Roseburn Air Pollution Modelling

An assessment of the Council Air Study published 14th Oct 2019 by John Lamb, retired SEPA expert with twenty years' experience in air pollution.

Figure 1: Schematic drawing showing environmental conditions that would exist in Roseburn Terrace (looking east to west)

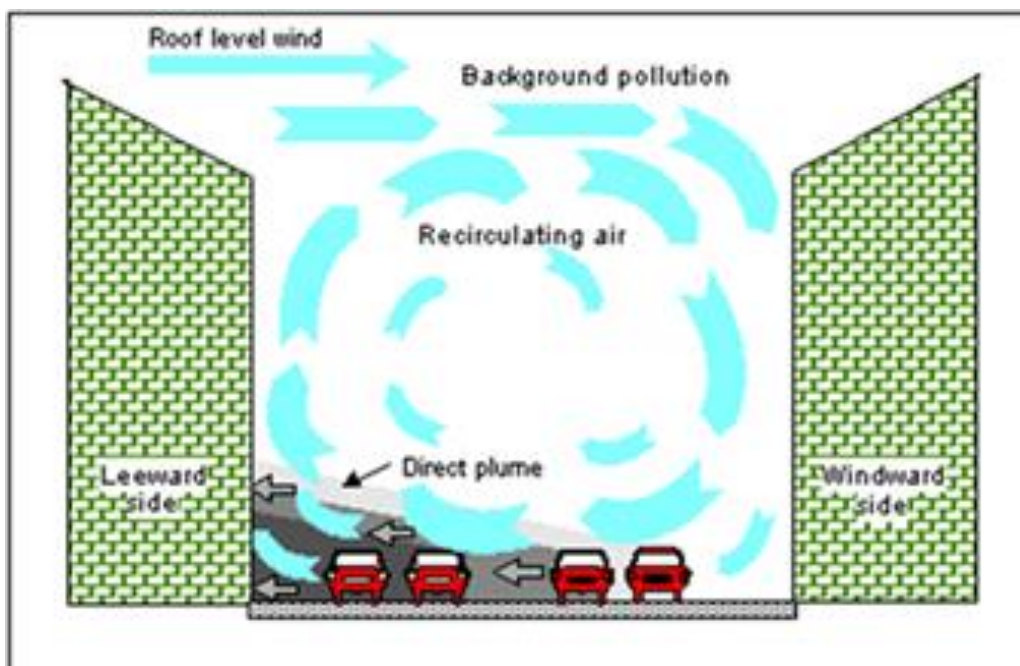
The proposed changes to the road layout will move traffic from the less polluted windward side of the street, to the more polluted leeward side. Traffic will also be moved one lane closer to the façade of the building, resulting in higher concentrations of NO₂ in an area where the levels are already sitting on the annual mean threshold.

Passive diffusion tube measurement (south side of Terrace)
Data from CEC Annual Progress Report 2018

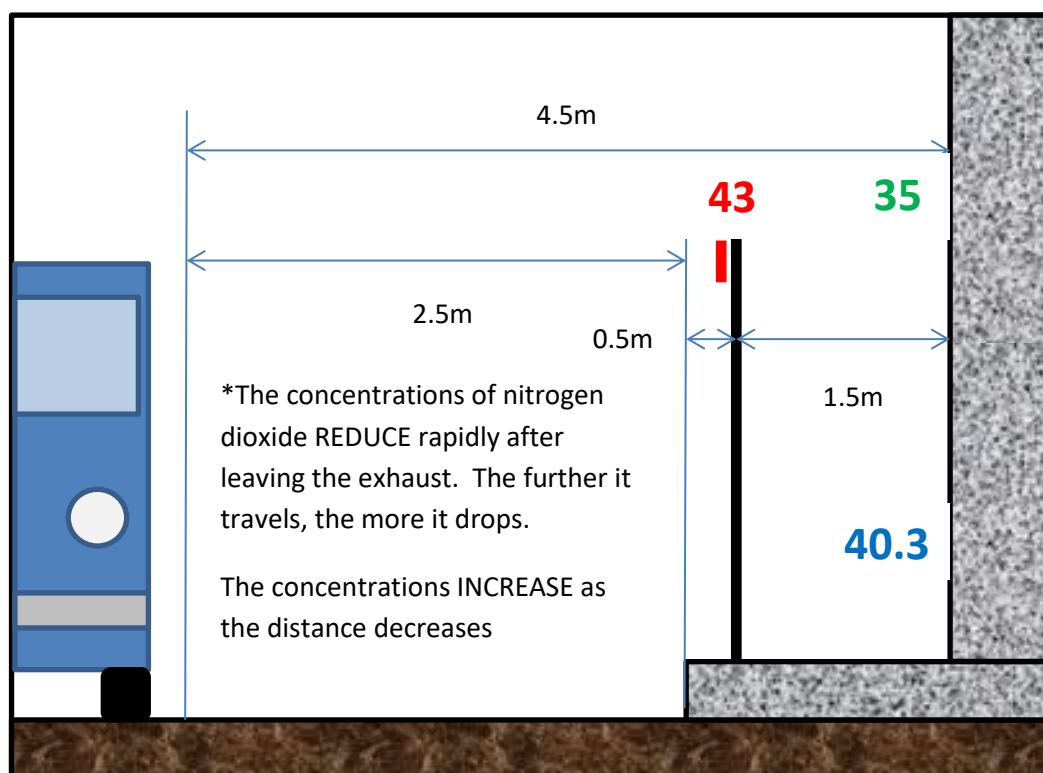
LAQM TG16 (Paragraph 7.79 states) clearly states “When using the NO₂ fall-off with distance calculator, it is important to justify the distances used in the calculation tool, as there may be circumstances when it is appropriate to treat the edge of the road (described within the tool as being the ‘kerb’) as being the edge of the carriageway with flowing traffic rather than the physical kerb, e.g. on some urban roads where the first lane is used for parking and therefore the flowing traffic is away from the physical kerb.”

City of Edinburgh Council has ignored the parked vehicles and used the edge of the kerb to correct measurement data. This has produced a figure that is below the statutory 40 µg.m⁻³ standard. If it had followed the guidance as described, the corrected figure is higher and slightly above the annual mean standard.

Appendix 4: Modelling study data appears to contradict the monitoring data.

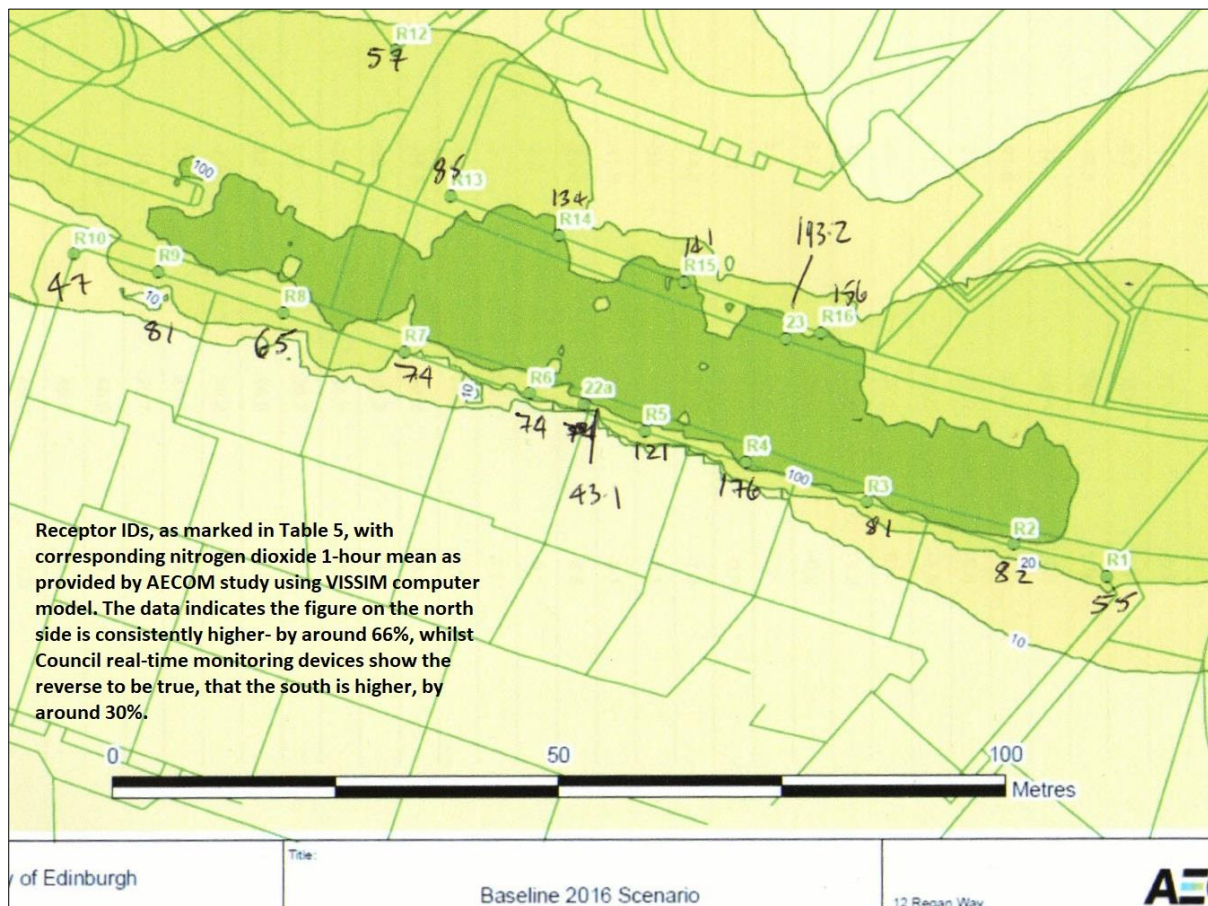
The measured concentrations of nitrogen dioxide on the south side are higher than those on the north side of the street, because Roseburn Terrace is a street canyon. Council monitoring confirms that this is the case. The data from the south side is consistently around 30% greater, as the AECOM Technical Director pointed out at the 15th October meeting. This data is shown in Table 1 above.

However, the report Baseline 2016 Scenario Model shows the receptor IDs, as marked in Table 5, with corresponding NO₂ 1-hour mean as provided by the AECOM study using the VISSIM computer model. The data is claiming the figure on the north side is consistently higher- by an average of around 66%, when we know the reverse is true.

This shows the approach taken for the study bears absolutely no relation to reality. I think this clearly explains why AECOM needed to validate their model - to see if the modelled figures match the monitoring data. And this has not been done. The model hasn't been validated; it needs to be tested against reality, in accordance with [LAQMTG16 Government Guidance](#). The guidance makes clear the ADMS model outputs need to be tested against local monitoring data. The consultant who wrote the report can't do that because there is no hourly monitoring data. So these are plots on a graph that has no scale; the figures have no reference, as they need to be adjusted with respect to real life measures. All we have are computer projections. Which are in fact claiming the opposite that reality tells us.
